## **Proposal for the 05 series of amendments to Regulation No. 10 (Electromagnetic compatibility)**

At its 69th session GRE agreed document GRE/2013/3 and Corr.1 from OICA together with additional amendments, as draft 05 series of amendments to Regulation No. 10 (GRE/69, paragraph 33). This has since become WP.29/2013/73, which was submitted to WP.29 and AC.1 for consideration at their November 2013 sessions as draft 05 series of amendments to Regulation No. 10.

Moreover, the OICA experts have consolidated the proposals of documents WP.29/2013/73 and GRE-70-14 in the present document, which constitute the current proposal for the 05 series of amendments to Regulation No. 10 and which supersedes WP.29/2013/73.

Figure 1  
HV artificial network

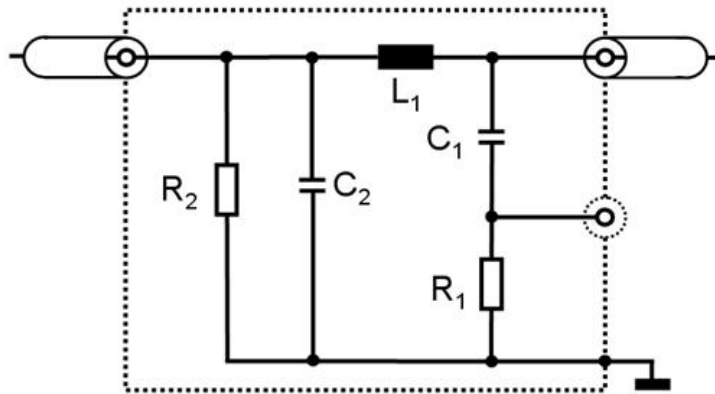
## "Appendix 8

### HV artificial network

<i>Legend</i>	$C_2: 0.1 \mu F$
$L_1: 5 \mu H$	$R_1: 1 k\Omega$
$C_1: 0.1 \mu F$	$R_2: 1 M\Omega$ (discharging $C_2$ to $< 50 V_{dc}$ within 60 s)

Figure 1  
**Vehicle in configuration "REESS charging mode coupled to the power grid" – Single phase charger test set-up**

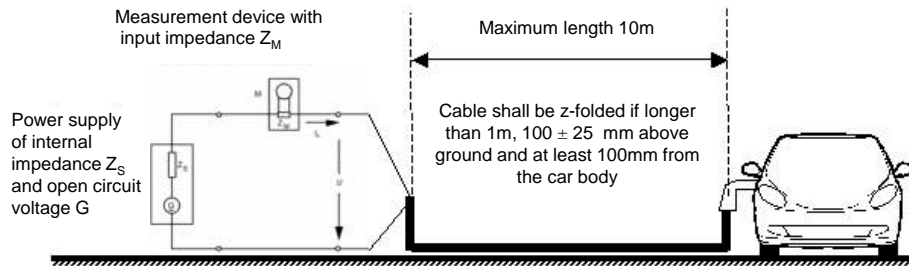
- 3.2. The test set-up for single phase vehicle in configuration "REESS charging mode coupled to the power grid" is shown in Figure 1 of the appendix to this annex.

Figure 2  
**Vehicle in configuration "REESS charging mode coupled to the power grid" – Three-phase charger test set-up**

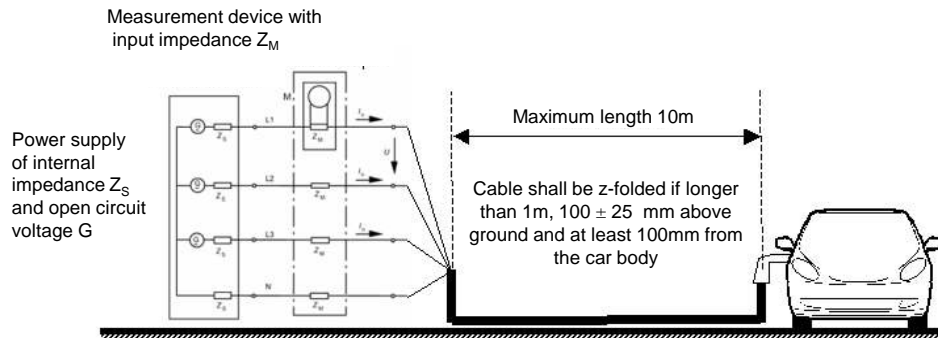
- 3.3. The test set-up for three-phase vehicle in configuration "REESS charging mode coupled to the power grid" is shown in Figure 2 of the appendix to this annex.

Figure 1a  
Vehicle in configuration "REESS charging mode coupled to the power grid" – Single phase test set-up

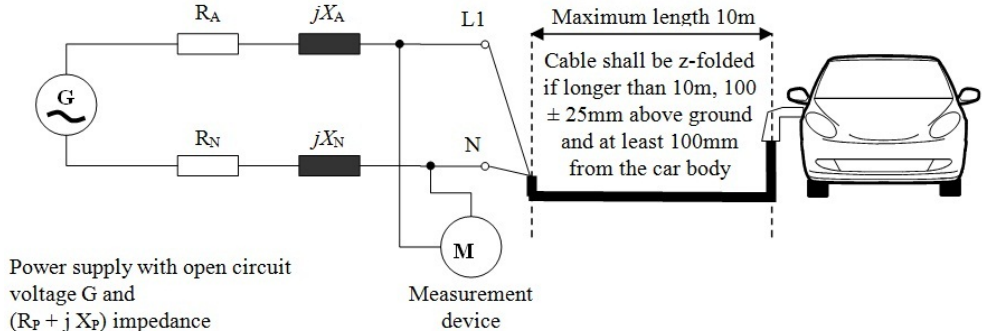
Annex 12, amend to read:

Figure 1  
Vehicle in configuration "REESS charging mode" coupled to the power grid coupling on AC/DC power lines

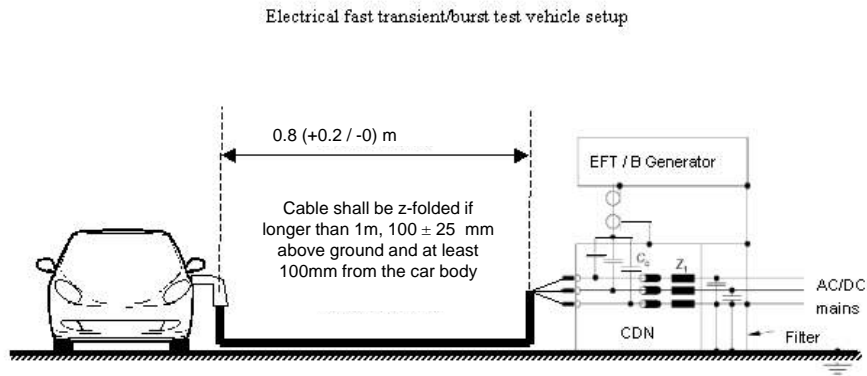
Annex 15, Appendix, amend to read:

The vehicle shall be positioned on the ground plane. The electrical fast transient/burst (EFT/B) shall be applied on the vehicle on the AC/DC power lines in common modes by using CDN as described in Figure 1 of the appendix to this annex.

Figure 1  
ESA in configuration "REESS charging mode coupled to the power grid" – Single phase test set-up

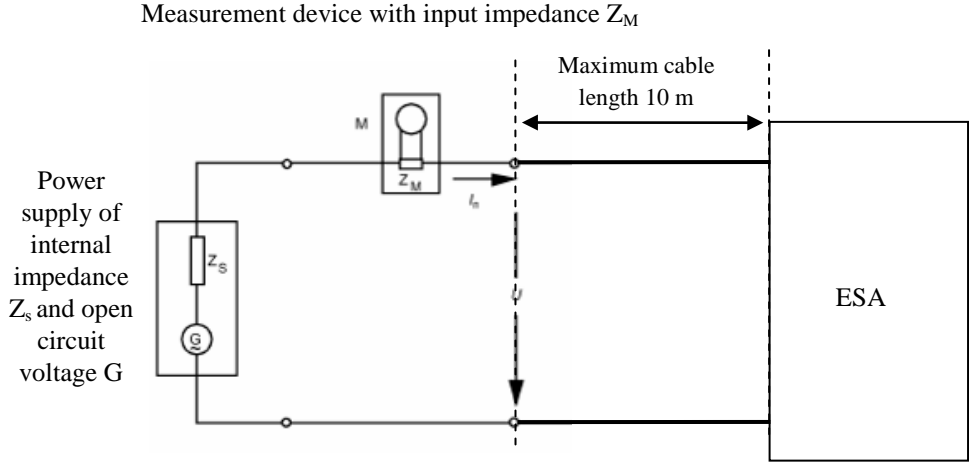
- 3.2. The test set-up for single phase ESA in configuration "REESS charging mode coupled to the power grid" is shown in Figure 1 of the appendix to this annex.

Figure 2  
ESA in configuration "REESS charging mode coupled to the power grid" – Three-phase-test set-up

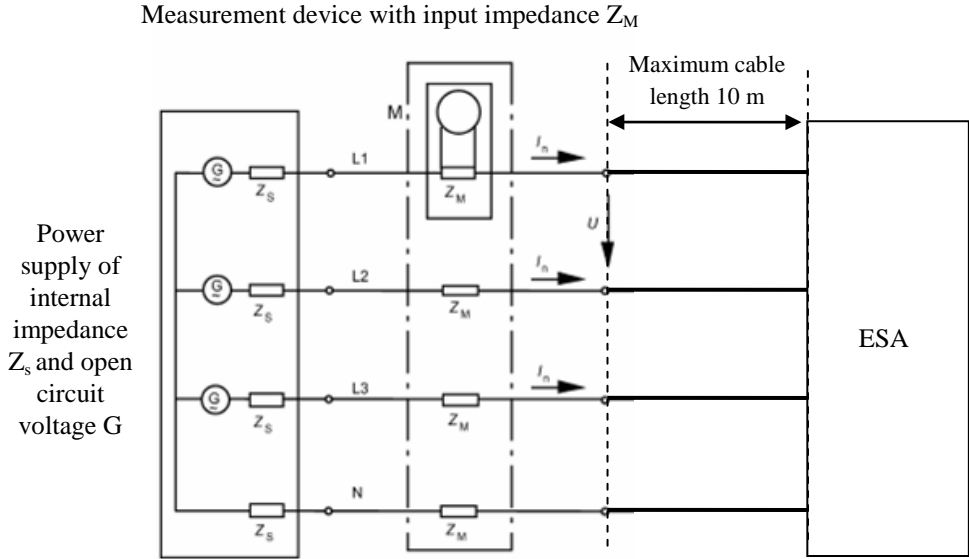
- 3.3. The test set-up for three-phase ESA in configuration "REESS charging mode coupled to the power grid" is shown in Figure 2 of the appendix to this annex.

Figure 1  
ESA in configuration "REESS charging mode coupled to the power grid"

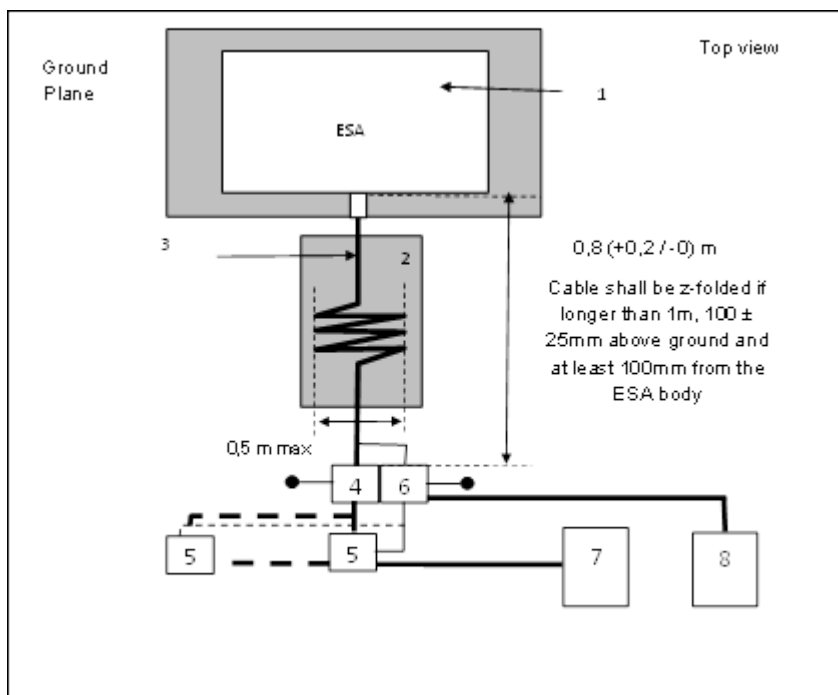
- 3.3. The test set-up for the connection of the ESA in configuration "REESS charging mode coupled to the power grid" is shown in Figure 1 of the appendix to this annex.
- 3.4. The measurements shall be performed with a spectrum analyser or a scanning receiver. The parameters to be used are defined in Table 1 and Table 2.

Figure 1  
ESA in configuration "REESS charging mode coupled to the power grid"

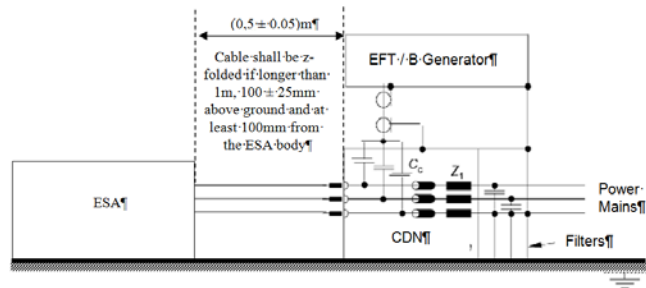
The ESA shall be positioned on the ground plane. The electrical fast transient/burst (EFT/B) shall be applied on the ESA on the AC/DC power lines in common modes by using CDN as described in Figure 1 of the appendix to this annex.
